BLUE BIRD

R10SL

Starter Cable and Wiring Harness May Contact Engine Fan Hub

Models Affected: 2007 – 2011 All American (A3FE) and Commercial Series (C3FE), and 2010-2011 All American (D3FE) equipped with Cummins ISB Engines

Replace with new locknut and flat washer (Note: new locknut shown)

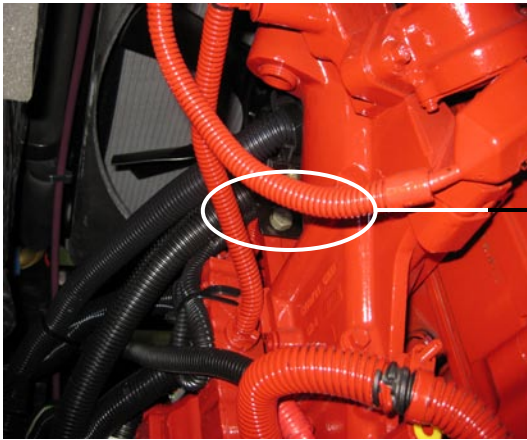
- 6 One starter cable and wiring harness support is located on the right side of the engine between the alternator and engine fan.
- 7 Remove and discard the 1/4" serrated nut (and flat washer if installed). Install the new 1/4" locknut (0145847) and flat washer (01247709) provided. Torque nut to 60-85 in. lbs. Note: two complete threads must extend completely through the nut.

Left Side support

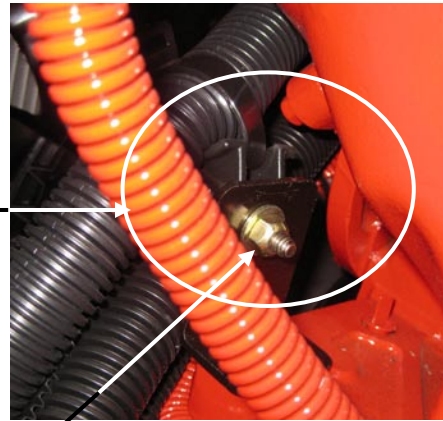
8. The second starter cable and wiring harness support is located on the front left side of the engine block.
9. Remove and discard the $\frac{1}{4}$ " serrated nut (and flat washer if installed). Install the new $\frac{1}{4}$ " locknut (0145847) and flat washer (01247709) provided. Torque nut to 60-85 in. lbs. Note: two complete threads must extend completely through the nut.

Replace with new locknut and flat washer (Note: New locknut shown)

Replace serrated nut
(shown) with new
locknut and flat washer

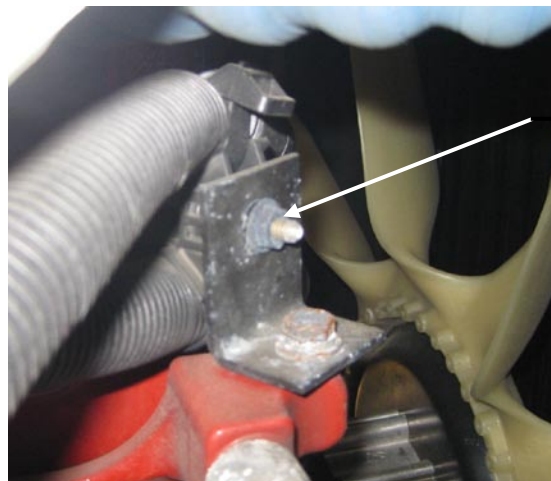
- 4 One starter cable and wiring harness support is located on the right side of the engine between the alternator and engine fan.
5. Remove and discard the $\frac{1}{4}$ " serrated nut (and flat washer if installed). Install the new $\frac{1}{4}$ " locknut (0145847) and flat washer (01247709) provided. Torque nut to 60-85 in. lbs. Note: two complete threads must extend completely through the nut.

Left Side Support

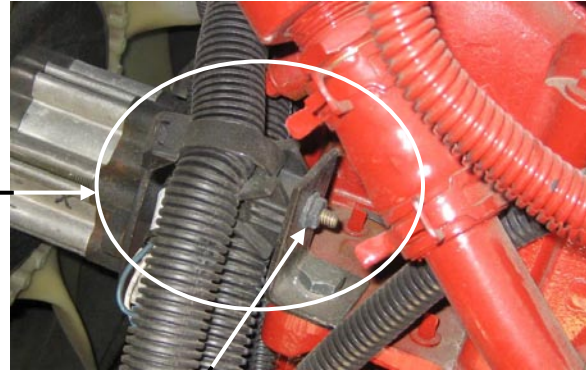
- 7 Remove and discard the 1/4" serrated nut (and flat washer if installed). Install the new 1/4" locknut (0145847) and flat washer (01247709) provided. Torque nut to 60-85 in. lbs. Note: two complete threads must extend completely through the nut.
 8. Reinstall the engine cover assembly by reversing the steps above. Reconnect the batteries.
- Caution:** *When reconnecting the batteries, connect the negative cable last.*
9. Place bus back in service.

Replace serrated nut (shown) with locknut and flat washer
